Item ID: D2580-1 Accept ***N900040100*** Setup Start ***NS1***
 Revision ID: 205 Skidtube bent detail Stop ***NS2***
 Item Name: 205 Skidtube bent detail
 Start Date: 06/02/2012 Start Qty: 2.00 ***2*** Cust Item ID:
 Required Date: 08/02/2012 Req'd Qty: 2.00 ***2*** Customer:
 Reference:

DRAWING NO. D2580	TITLE 205 SKIDTUBE ASSEMBLY	REV. E	DART AEROSPACE LTD ENGINEERING ORDER	D.E.O. NO. D2580-E-1	SHEET NO. SHEET 1 OF 1	SCALE NTS
DRAWN <i>JP</i>	CHECKED <i>ASS</i>	MFG. APPR. <i>EC</i>	APPROVED <i>[Signature]</i>	DE APPR. <i>[Signature]</i>		
DATE 11.12.13	DATE 11.12.13	DATE 11.12.13	DATE 11.12.13	DATE 11.12.13

PURPOSE:

CHANGE ALL C'BORED WELDED CROSSBOLT SPACERS TO SWAGED SPACERS

SECTION B-B, F-F, I-I
NOT TO SCALE

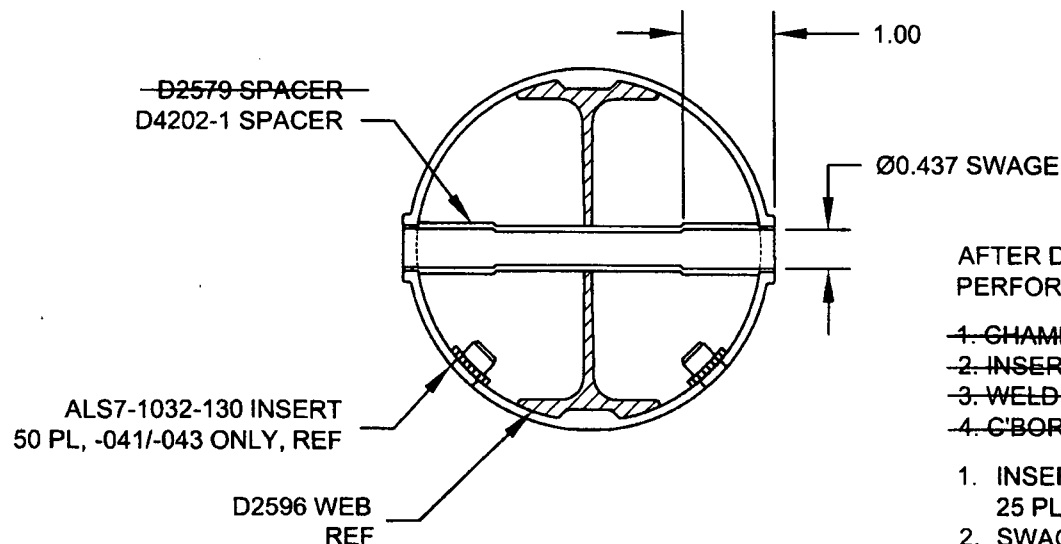
SECTION B-B, SECTION F-F, & SECTION I-I ARE AMENDED AS FOLLOWS
FOR ALL HOLES THAT WERE ORIGINALLY C'BORED:

*** FOR -045 SKIDTUBE ONLY:**
WELD 4X D2579 SPACERS PER DWG
IN LOCATIONS MARKED "NO C'BORE".
REF SHEET 4 OF DWG.

- ~~1. CHAMFER HOLE 0.050 X 45°~~
- ~~2. INSERT D2579 SPACER (20 PLACES)~~
- ~~3. WELD INTO PLACE AND GRIND FLUSH~~
- ~~4. C'BORE D2579 SPACER TO Ø0.437 X 1.00 DEEP~~

1. INSERT D4202-1 SPACER, 20 PL (-041) OR 20 PL (-045) OR 25 PL (-047)
2. SWAGE TO Ø0.437 X 1.00 DEEP PER QSI 002
3. TRIM / GRIND FLUSH PER QSI 002
